# CITY OF PITTSBURG

## MT. DIABLO RESOURCE RECOVERY PARK

### FINAL ENVIRONMENTAL IMPACT REPORT

**2.0 COMMENTS AND RESPONSES TO COMMENTS ON THE DRAFT EIR**

3-6

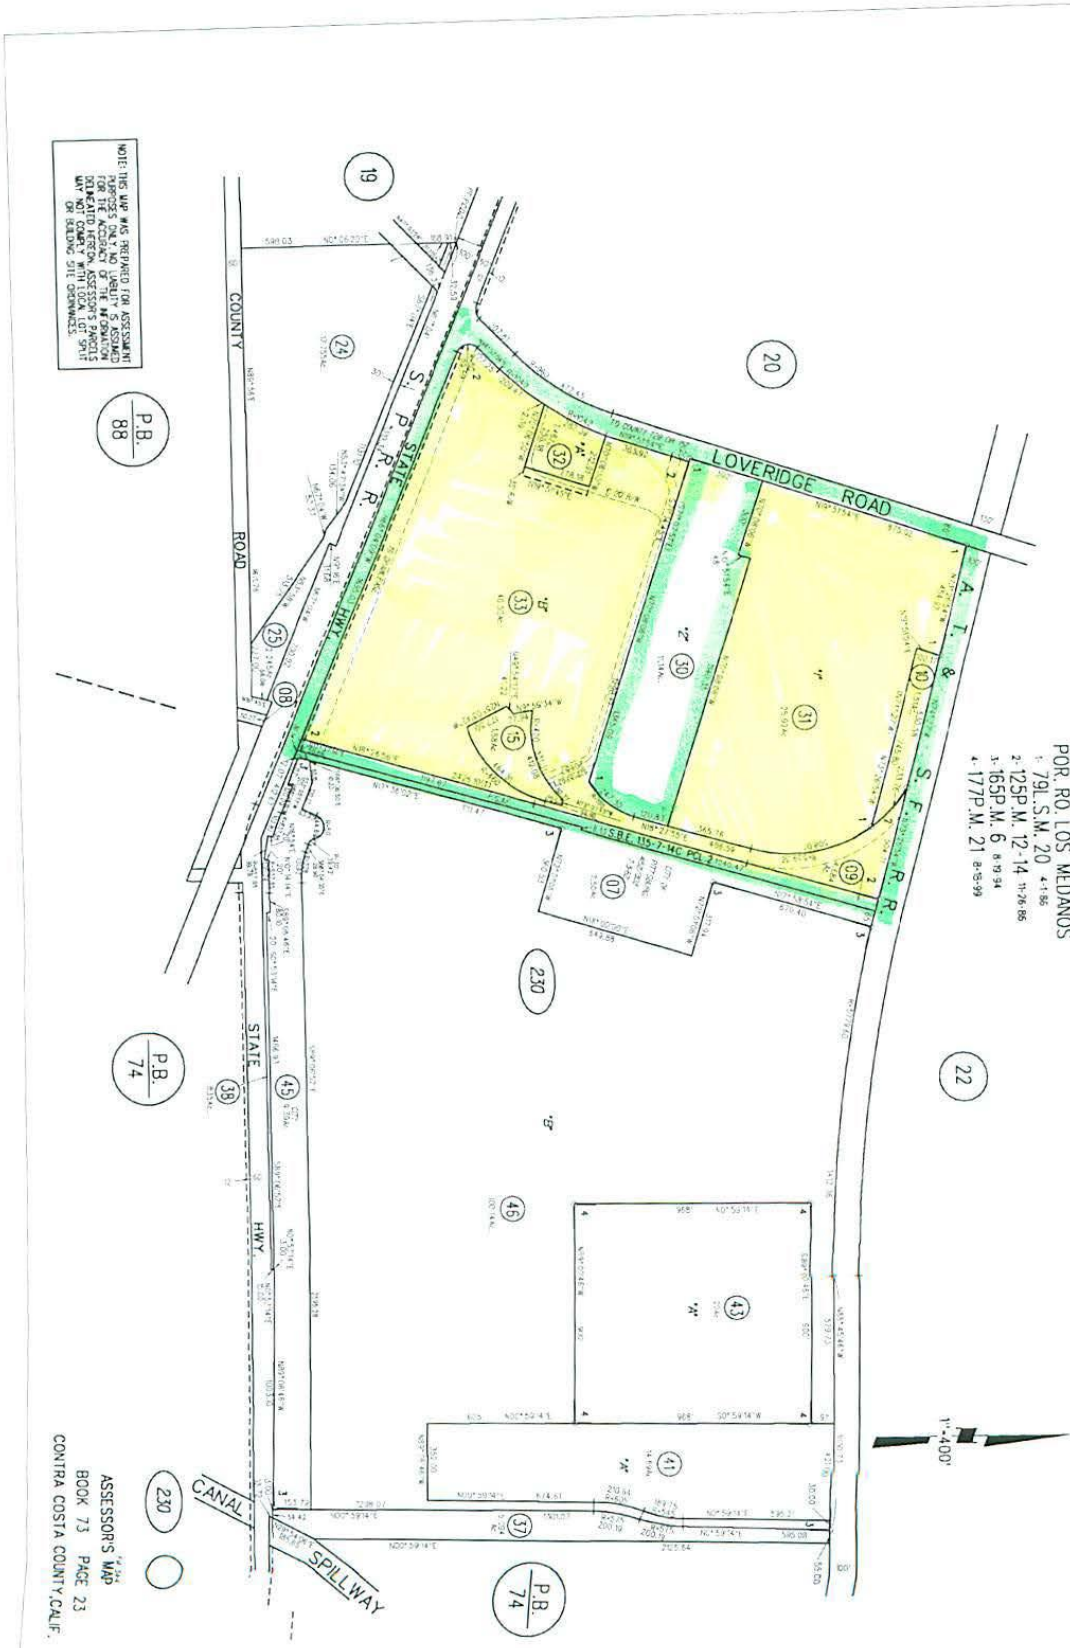
State CEQA guidelines and the BAAQMD consider that the particulate impacts from MDRF and RCTS are significant if the expose sensitive human receptors to substantial pollutant concentrations. Even prior to the expansion of MDRF and RCTS activities, there are current existing negative impacts on humans at CCIP. The materials that are airborne may include lead dust from household wood that has been delivered to MDRF and RCTS for recovery. As there are no air monitoring stations in east county or proximate to this site, we have no meaningful way to test what the future additional air quality impacts may be in order to protect the human receptors.

The commenter is referred to Response 3-2 regarding the project's potential air quality impacts evaluated in the DEIR. As discussed in Response 3-3, dust is considered a nuisance and is not a regulated air pollutant. Regarding lead from household wood waste, the removal of lead paint during building demolition and renovation is regulated at the federal and state levels to ensure worker safety. Therefore, construction and demolition materials accepted at the facility are not anticipated to contain lead-based paint. Furthermore, as discussed on DEIR page 2.0-8, construction and demolition materials entering the facility would be sorted and transported off-site for disposal or further processing. No grinding of these materials would occur on-site or contribute to dust migrating off-site.

Letter 4 Continued

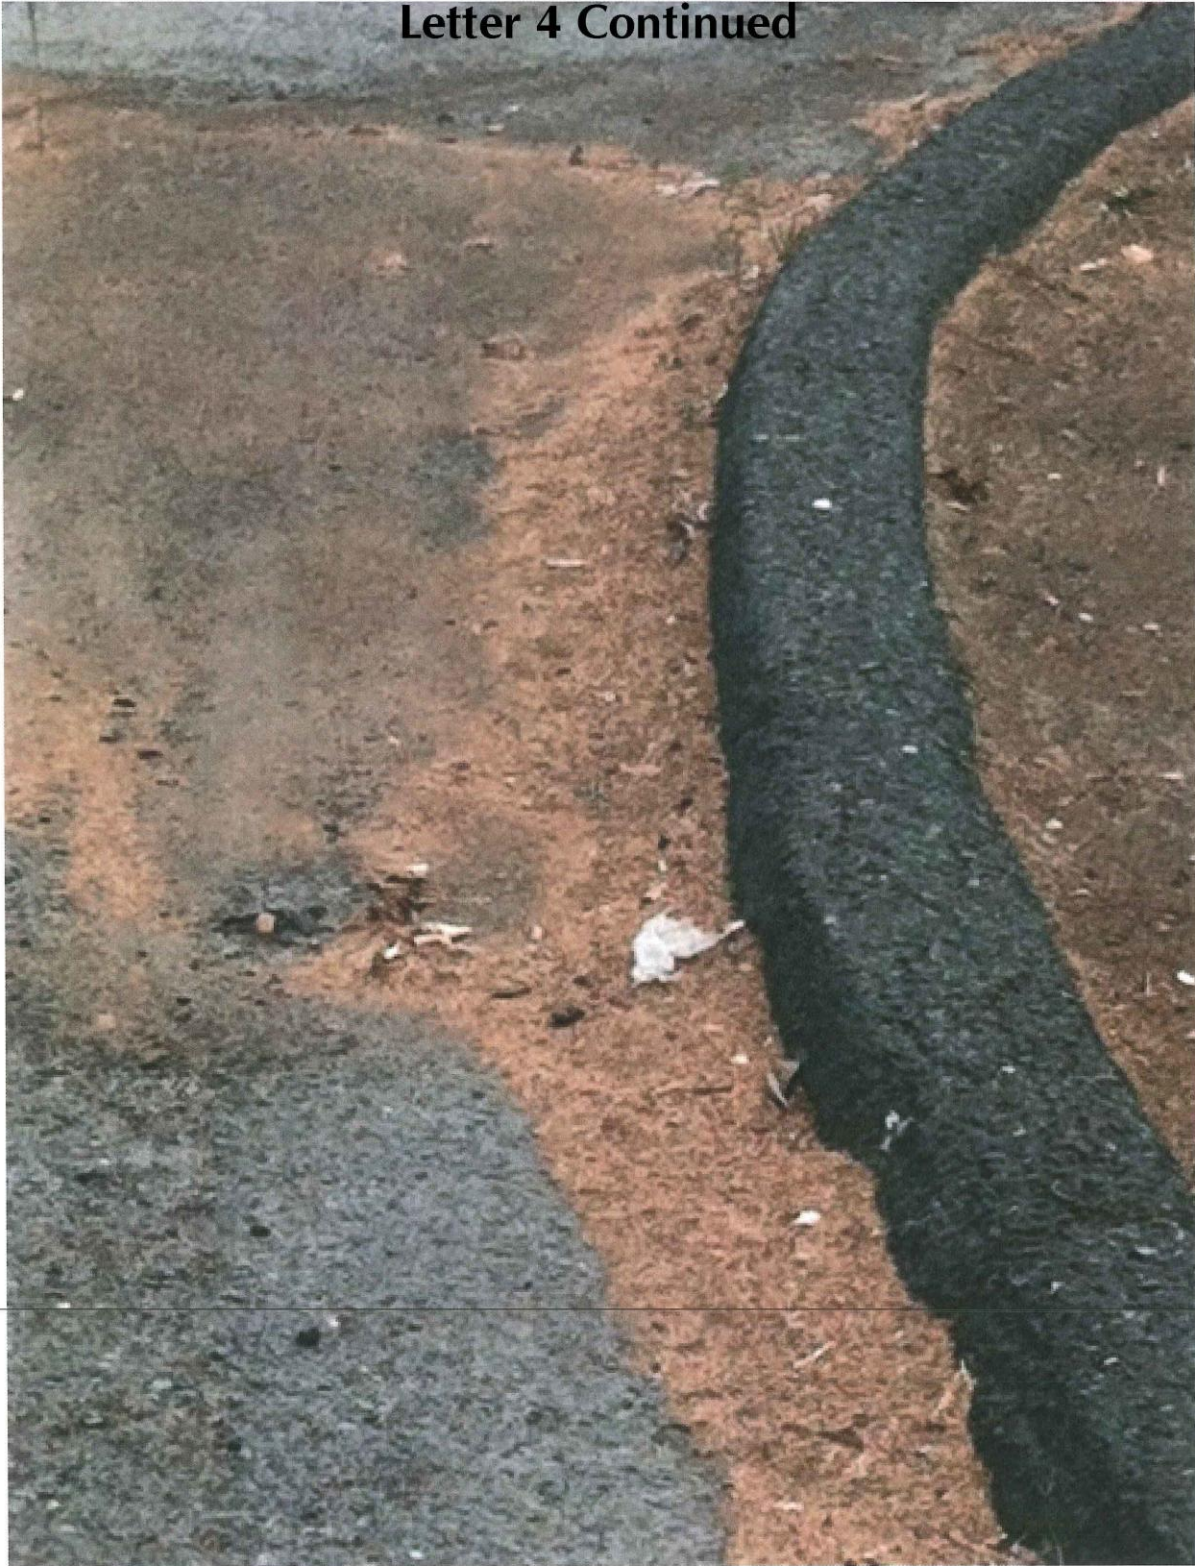
As I am sure you are aware, these facilities are very near the Delta which results in constant winds. I know most similar facilities I see have netting or something similar up high to better contain the dust, garbage, etc. from blowing all over the place. I had asked earlier that you consider putting up something as described or propose something similar as a preventative measure. As of today I have not received any further response from you. I have no other option but to insist this be addressed immediately.

The commenter is referred to Response 3-4 and DEIR page 2.0-39. The project proposes implementation of a dust minimization plan (see DEIR Appendix C), which includes specific measures to control dust during project construction and operation. The plan includes measures that are currently implemented at the existing facility such as the use of street sweepers and a water truck in addition to newly proposed measures such as the use of misting systems, the addition of a second water truck, paving of access roads, wind-level monitoring, and worker education/awareness training. In addition, mitigation measure MM 3.1.1 (see DEIR pages 3.1-26 and -27) requires the project to implement BAAQMD-recommended best management practices for the control of fugitive dust during project construction including the posting of contact information for dust complaints. Compliance with these existing regulations would minimize dust generation during project construction and operation and provide an opportunity for neighboring property owners to address dust complaints. See Response 3-4 regarding health effects of facility operations.
